DRAWING NO. D205-596-107	TITLE CROSSTUBE ASS'Y, HI-HI AFT	REV. B	DART AEROSPACE LTD ENGINEERING ORDER		D.E.O. NO. D205-596-107-B-2	SHEET NO. SHEET 1 OF 1	SCALE NTS
DRAWN <i>q</i>	CHECKED <i>A.P.</i>	MFG. APPR. <i>A</i>	APPROVED <i>MP</i>		DE APPR. <i>#</i>		
DATE 13.11.11	DATE 13.11.14	DATE 13.11.19	DATE 13/11/21		DATE 13/11/21

PURPOSE:

REPLACE MAGNOBOND WITH PROSEAL.

DRAWING NO. D205-596-107	TITLE CROSSTUBE	REV. B	DART AEROSPACE LTD ENGINEERING ORDER	D.E.O. NO. D205-596-107-B-3	SHEET NO. SHEET 1 OF 1	SCALE NTS
DRAWN <i>q</i>	CHECKED <i>A.P.</i>	MFG. APPR. <i>AA</i>	APPROVED <i>AS</i>	DE APPR. <i>HT</i>		
DATE 15.01.15	DATE 15.01.20	DATE 15.01.20	DATE 15.01.20	DATE 15.01.20

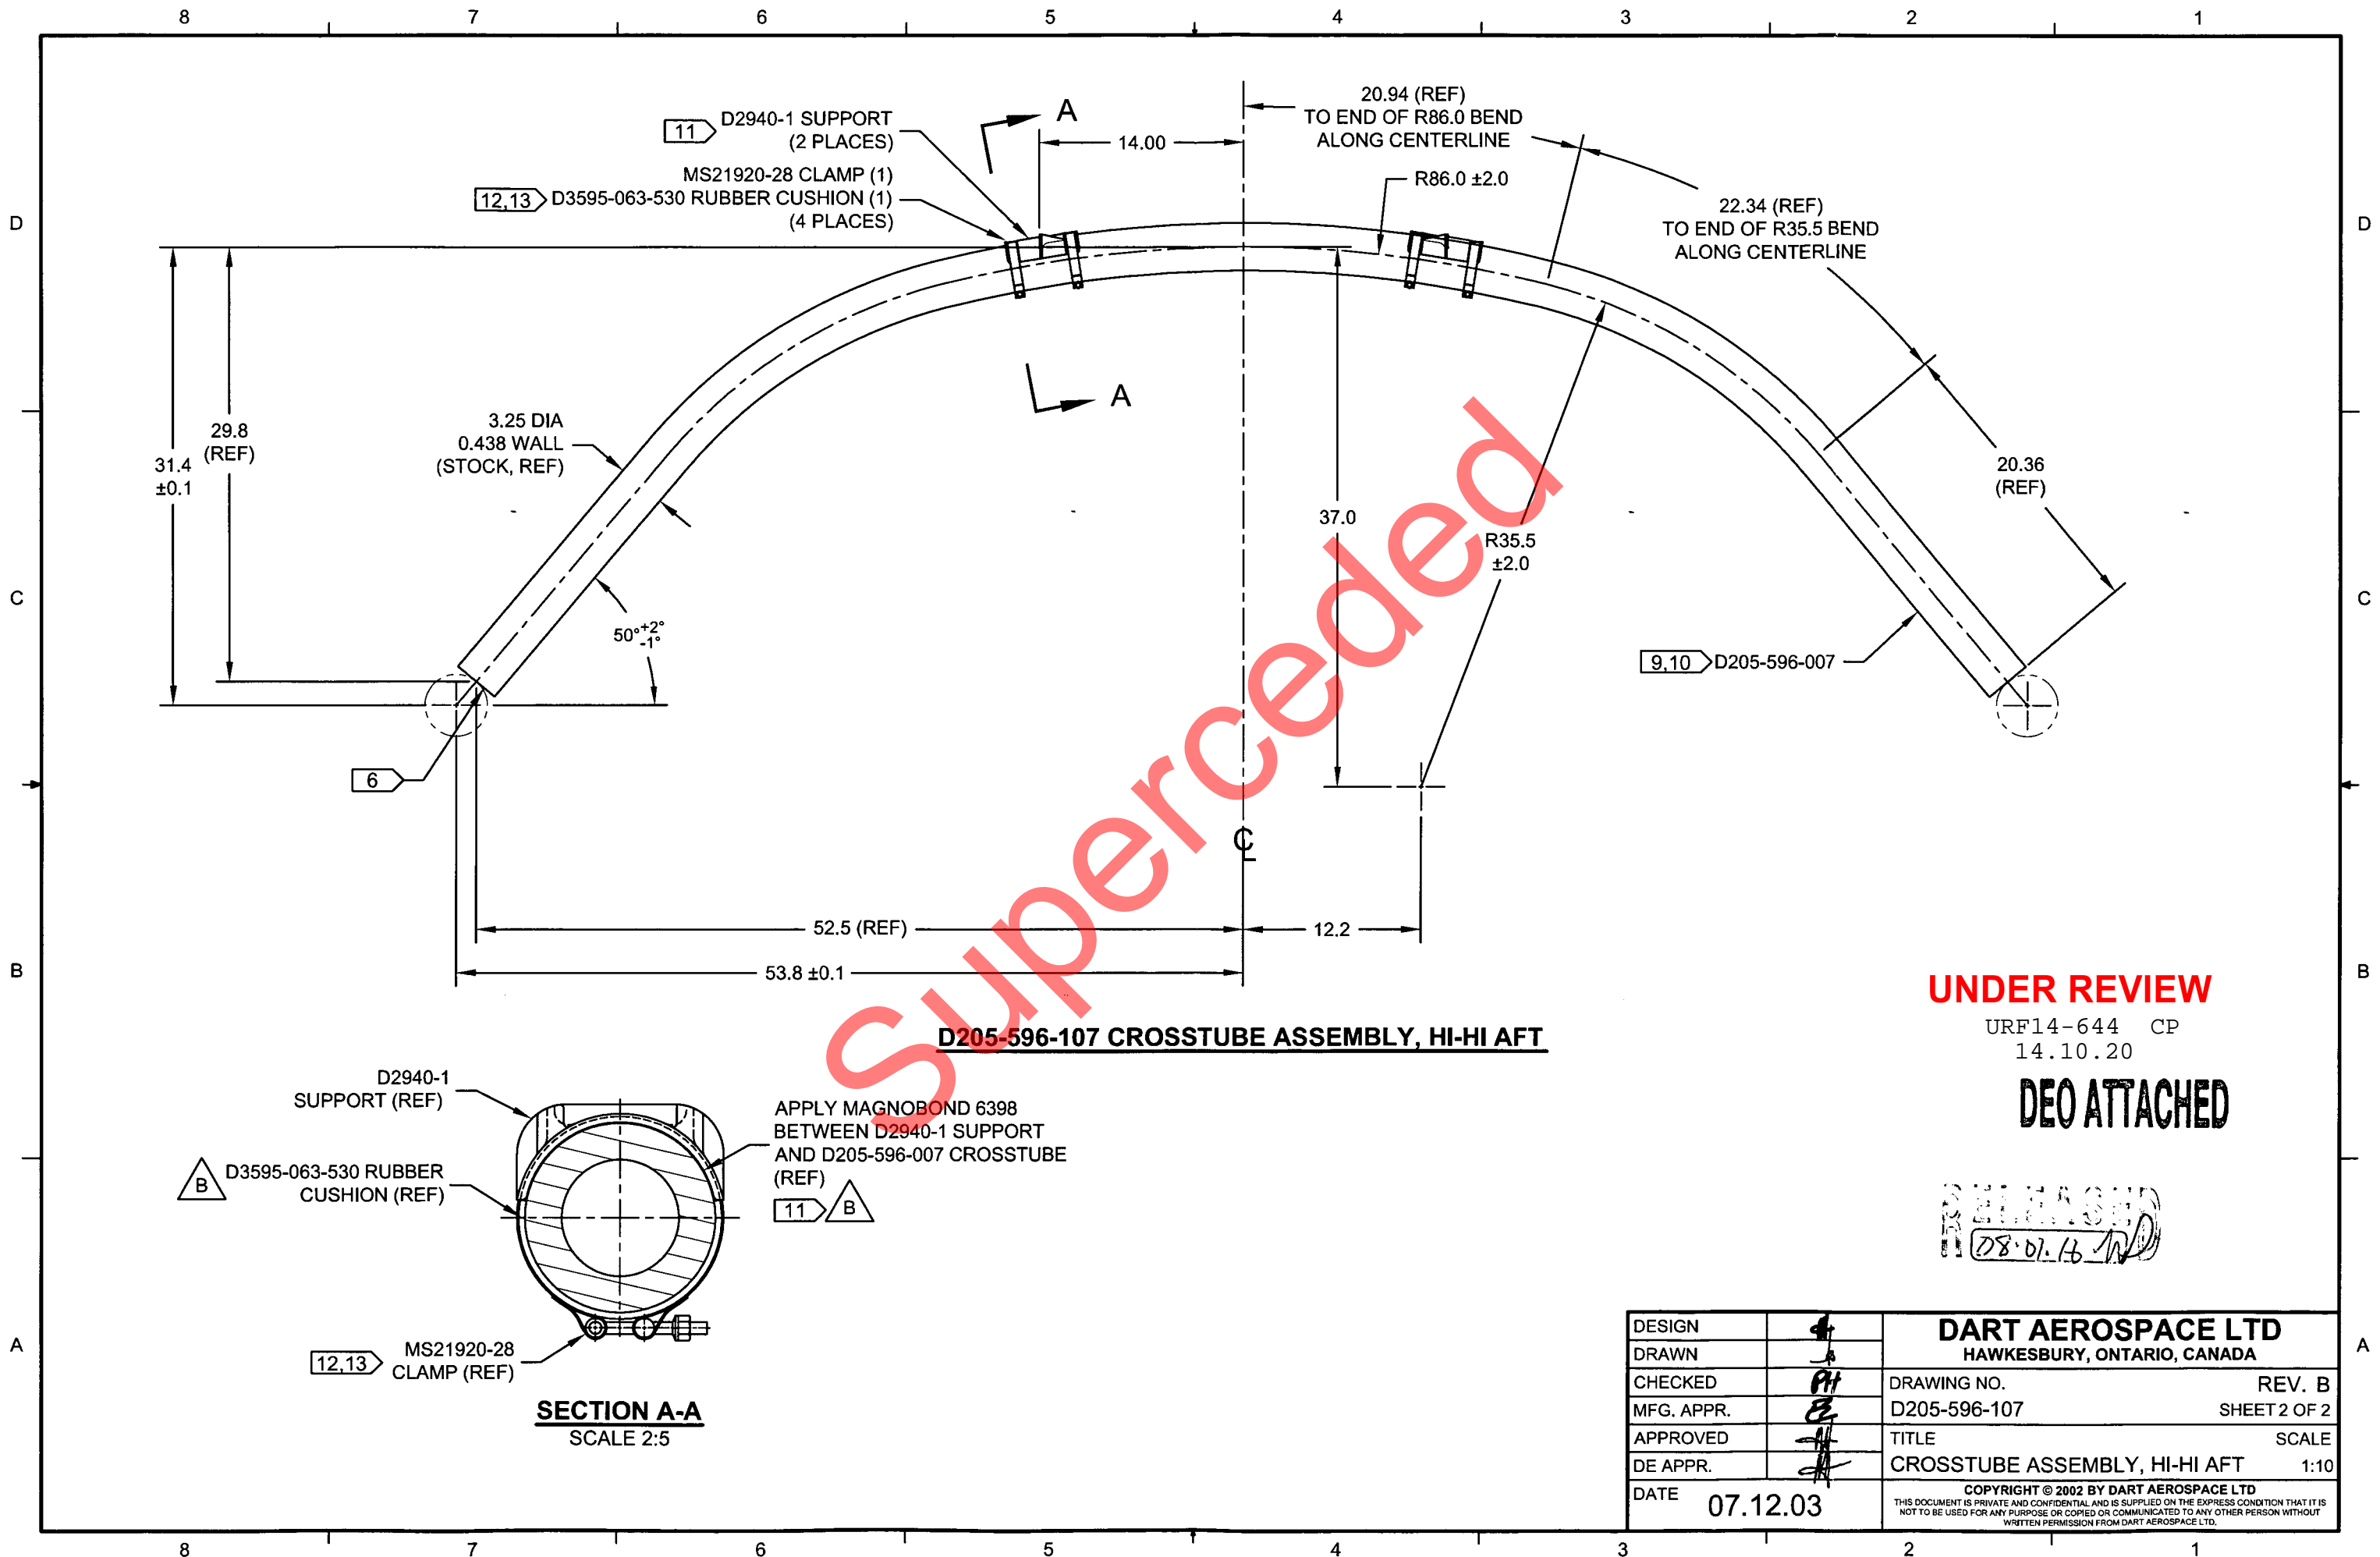
B	SUPPORT NOW MAGNOBONDED; REMOVE D2856-600-1009 ABRASION STRIP; UPDATED NOTES; ADDED D3595-063-530 CUSHION	MB	07.12.03
A	NEW ISSUE	DS	02.11.20
REV.	DESCRIPTION	BY	DATE
DESIGN	<i>[Signature]</i>	DART AEROSPACE LTD	
DRAWN	<i>[Signature]</i>	HAWKESBURY, ONTARIO, CANADA	
CHECKED	<i>[Signature]</i>	DRAWING NO.	REV. B
MFG. APPR.	<i>[Signature]</i>	D205-596-107	SHEET 1 OF 2
APPROVED	<i>[Signature]</i>	TITLE	SCALE
DE APPR.	<i>[Signature]</i>	CROSSTUBE ASSEMBLY, HI-HI AFT	NTS
DATE	07.12.03	COPYRIGHT © 2002 BY DART AEROSPACE LTD <small>THIS DOCUMENT IS PRIVATE AND CONFIDENTIAL AND IS SUPPLIED ON THE EXPRESS CONDITION THAT IT IS NOT TO BE USED FOR ANY PURPOSE OR COPIED OR COMMUNICATED TO ANY OTHER PERSON WITHOUT WRITTEN PERMISSION FROM DART AEROSPACE LTD.</small>

NOTE 11 & 13, SHEET 1 IS AMENDED AS FOLLOWS:

- 11) APPLY A 0.03" TO 0.06" THICK LAYER OF MAGNOBOND 6398 TO THE SURFACE OF D2940-1 THAT WILL BE IN CONTACT WITH THE CROSSTUBE. LET CURE FOR 12 HOURS AFTER INSTALLATION AND PRIOR TO PACKAGING.
- 13) TORQUE CLAMPS 80 TO 100 IN-LB.

- 11) TO INSTALL D2940-1 SUPPORT: ABRASE MATING SURFACE OF SUPPORT AND CROSSTUBE WITH 180-GRIT SANDPAPER AND REMOVE RESIDUE WITH MEK (OR EQUIVALENT). APPLY A 0.04" TO 0.07" THICK LAYER OF PROSEAL 890 CLASS B-2 (OR AMS-S-8802 CLASS B-2) SEALANT TO MATING SURFACE OF SUPPORT.
- 13) TORQUE CLAMPS 80 TO 100 IN-LB. ENSURE AT LEAST 1.5 THREADS SHOWING IN SAFETY AND THAT NUT HAS NOT BOTTOMED-OUT AFTER TORQUING. PRIOR TO PACKAGING, RE-CHECK TORQUE ON CLAMPS AFTER PROSEAL 890 SEALANT HAS CURED FOR 72 HOURS.

FIGURE 1 - SUPPORT INSTALLATION

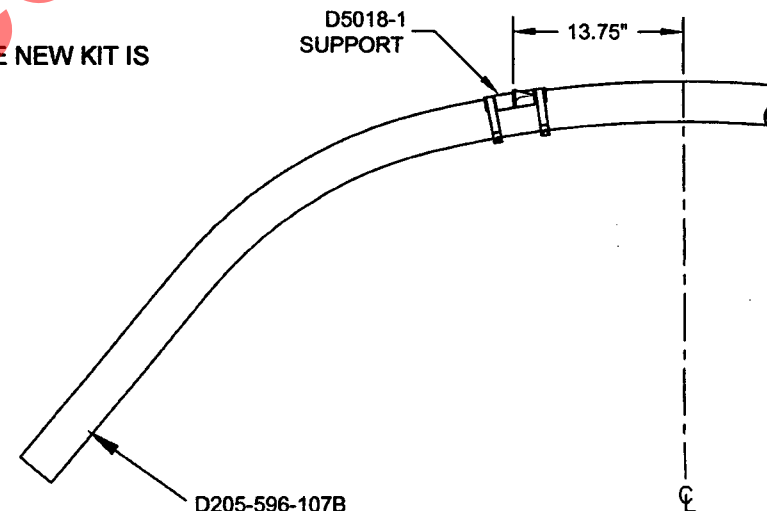
THE D205-596-107B CROSSTUBE HAS THE SAME PARTS LIST AS THE D205-596-107 CROSSTUBE EXCEPT AS FOLLOWS:

2	D2940-1	SUPPORT
---	---------	---------

2	D5018-1	SUPPORT
---	---------	---------

INSTALL THE SUPPORTS AS SHOWN IN FIGURE 1 OF THIS ENGINEERING ORDER. THE NEW KIT IS OTHERWISE ASSEMBLED PER THE D205-596-107 CROSSTUBE.
